# 2018 Integrated Resource Plan

## Stakeholder Workshop #4

December 18, 2018  
Plainfield, IN

## Duke Energy Indiana 2018 Integrated Resource Plan

## Typical Residential Load Shapes

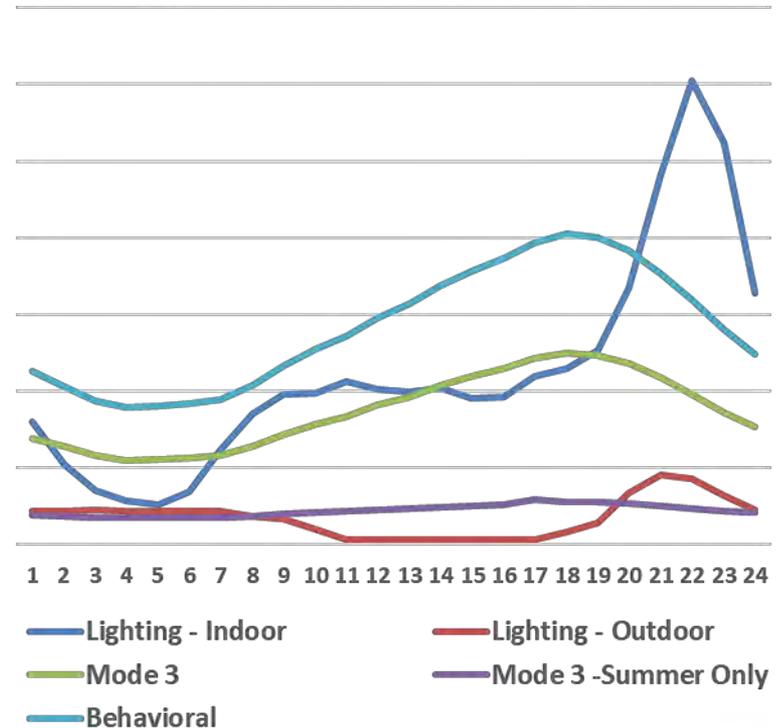
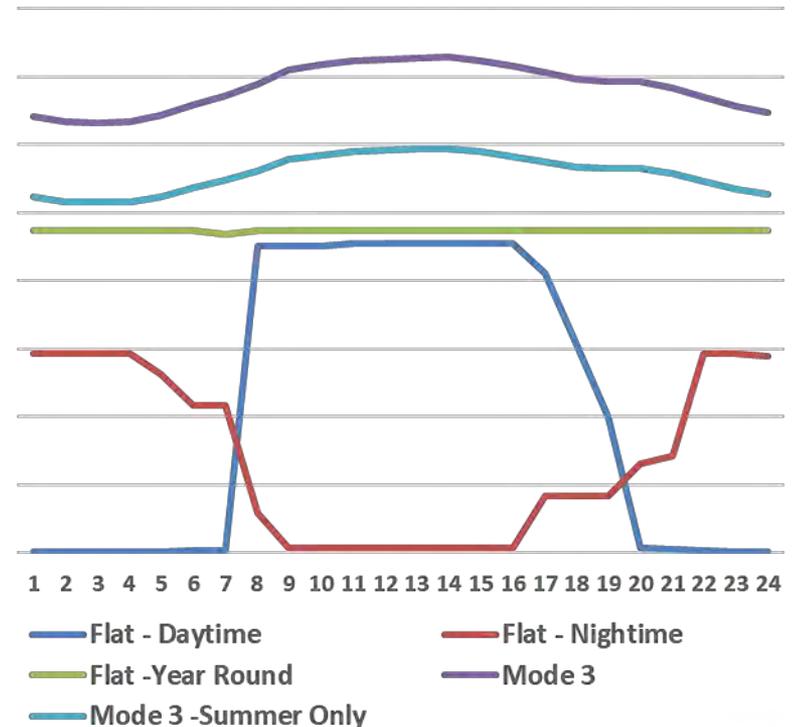
Stakeholder question: This stakeholder group provided comments to Duke with respect to the EE MPS. When this EE data was analyzed by this stakeholder group, they could not match what these graphs depicted. The stakeholder restated their proposal for decrement load for EE modeling. The stakeholder would like to have further conversation on this. The stakeholder group would also like Duke to share their comments on the MPS with the rest of the stakeholders. This stakeholder group does not think the MPS makes sense, and states that Duke should use the decrement approach. Using data that is not accurate from the MPS would be a mistake. One example would be residential lighting. The group also states that the MPS does not include emerging technologies. The stakeholder states that where there is more consumption, there is more opportunity for savings and an EE decrement with the same hourly shape as load could capture the benefit of emerging technology in this space, making the decrement method a potentially more accurate prediction of the future. Stakeholder agrees to disagree on validity of MPS.

Response: The graphs on slides 10 and 11 represent the load on a single peak summer day, based on the MPS hourly data that was sent. These illustrations are meant to be representative of how each looks a little different on a peak day. The Duke Energy EE team is reviewing memos sent by the stakeholder group. One advantage of bundle selection over the proposed decrement method is its link to actual EE measures. Reducing the 6000+ measures down to 70 bundles is difficult, but the result reflects plausible savings shapes. Reducing load by 0.25% would provide an estimate of cost savings, but crafting a set of measures that matches both the shape and the cost of the decrement would be difficult.

# Optimized Portfolios: Add Reference, No Carbon

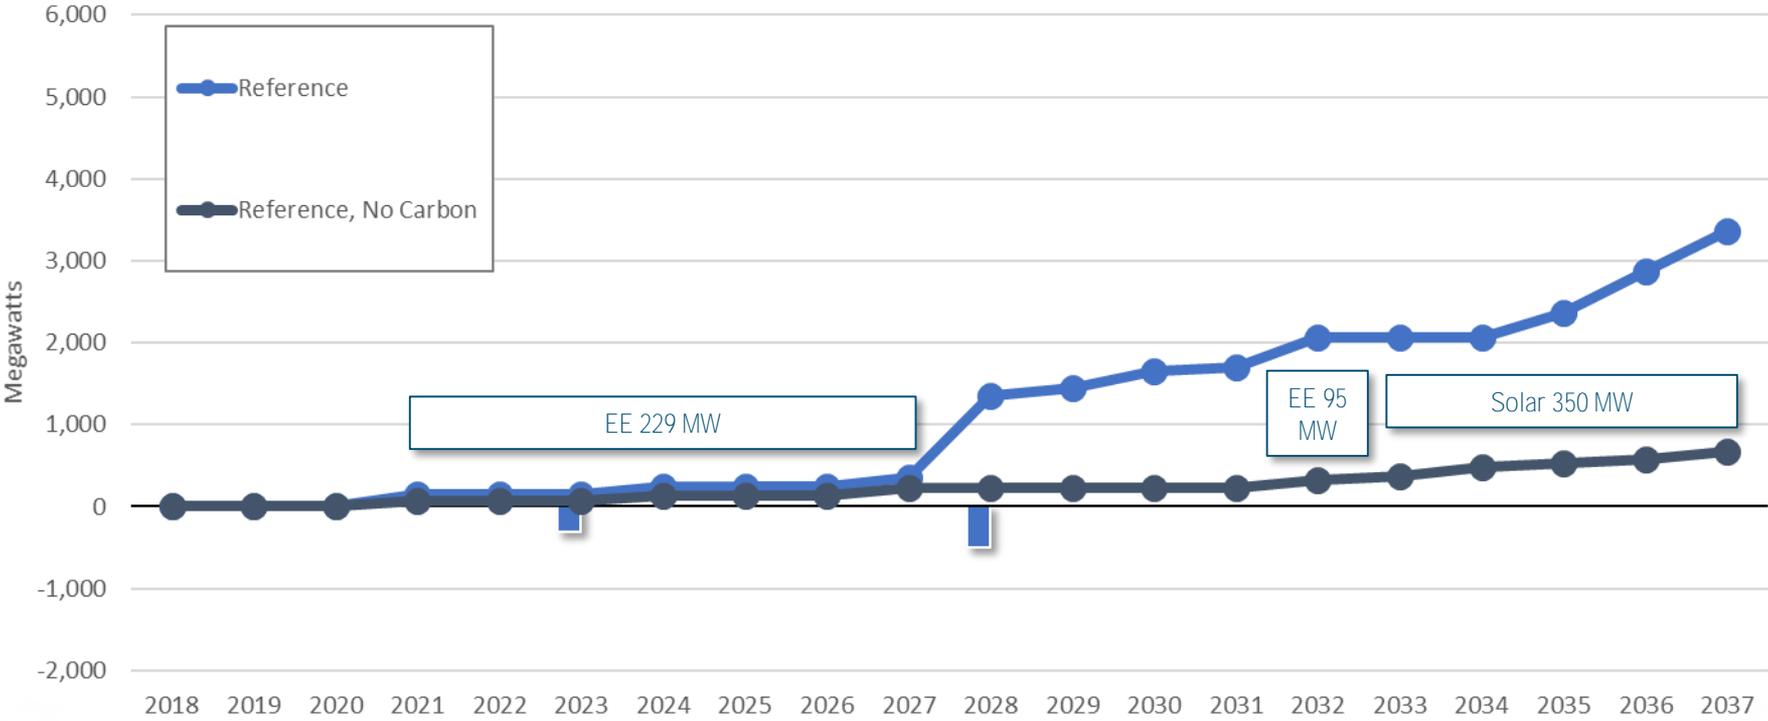
Stakeholder question: The stakeholder confirms that the retirement bars are not applicable to this case.

Response: Correct. Nate points out that the graphs are layered on top of each other, so the line and bars in the light blue are only applicable to the Reference scenario, and likewise for the dark blue and green going forward for Reference-No Carbon and High Tech Future scenarios.

# Capacity & Energy Mixes: Reference Case

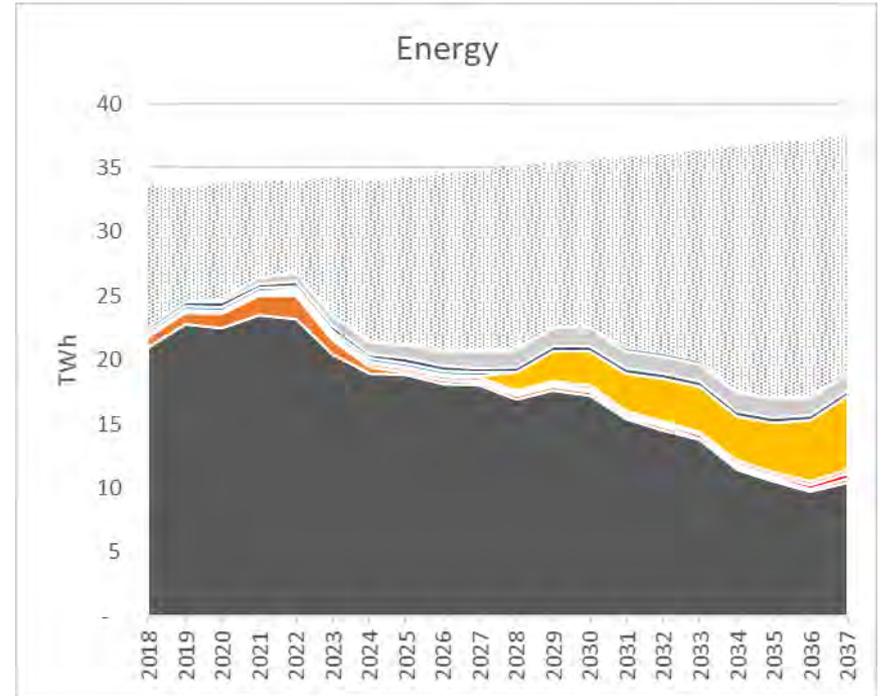
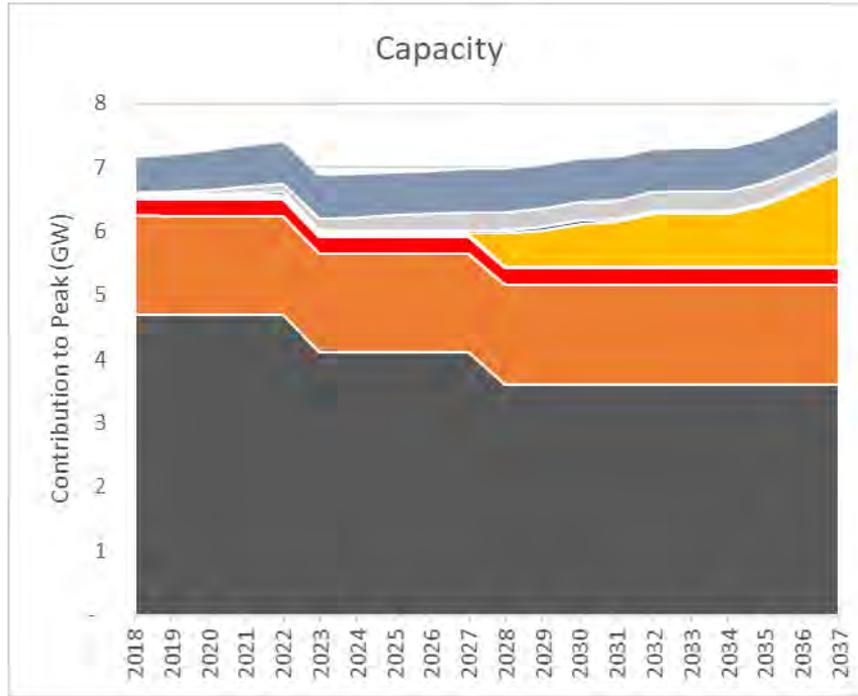
Stakeholder question: The Coal steps down correspond to which retirements? Energy mix of coal is declining over time. Just due to capacity change?

Stakeholder question: Why does Gibson 5 retire in 2023, before the carbon tax? And why is Coal generation growing through 2021?

Stakeholder question: It was noted by Brian that this case corresponds to a ~65% CO2 emissions reduction. What is this relative to? What are the CO2 emissions for the baseline year and the final year?

Stakeholder question: Does Duke consider the market purchase as no carbon?

Response: The retirements in this case are Gallagher 2 and 4, and Gibson 5 units in 2023 and then Cayuga 2 in 2028. Reducing capacity leads to less coal generation, but capacity factors also fall due to the economics of running those units after implementation of a carbon tax.

Response: Gibson 5 in this optimized portfolio is just the right size to retire and still meet the reserve margin requirement. Retiring this unit and not carrying extra capacity is the economic decision here. The coal generation increase is likely due to fuel and power price interrelationships; the model decides that it's better to generate with coal from our units in those years rather than buy from the market.

Response: This 65% reduction was relative to 2010 CO2 emissions numbers. The CO2 actuals and projections will be presented in the next meeting

Response: Market purchases here are obviously not carbon free, but we don't count carbon associated with purchases in this number. Something to consider in the hybrid portfolios, limiting market purchases to ensure CO2 reductions overall.

# Capacity & Energy Mixes: Ref. – No Carbon Tax

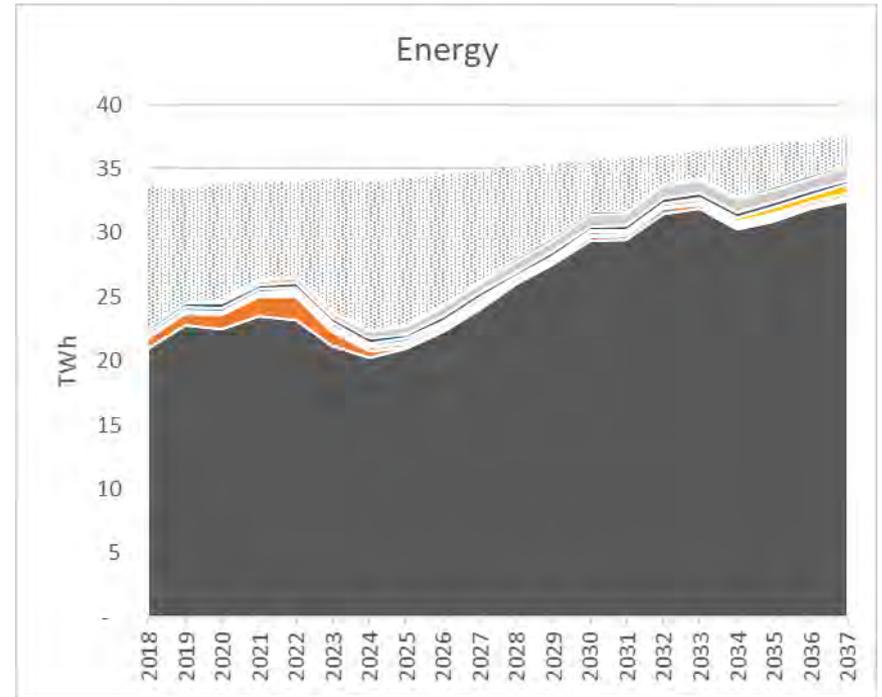
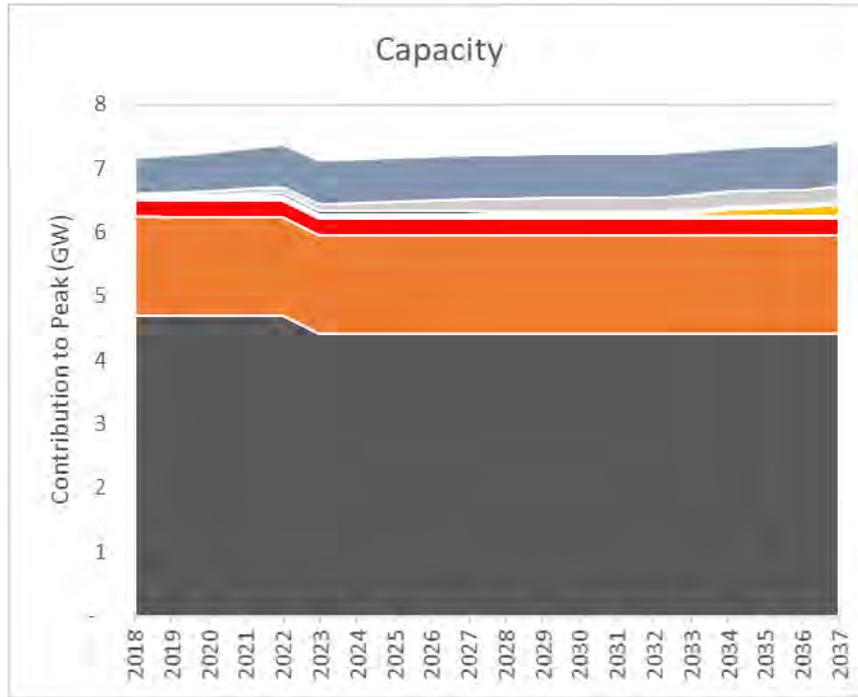
Stakeholder question: The stakeholder wants clarification that the only change is the elimination of the carbon tax. Does this mean the price of market purchases did not change?

Response: The market prices were changed to reflect the lack of a carbon tax. These power prices were developed based on an Eastern Interconnection expansion plan based on a no carbon tax scenario with all other reference projections.
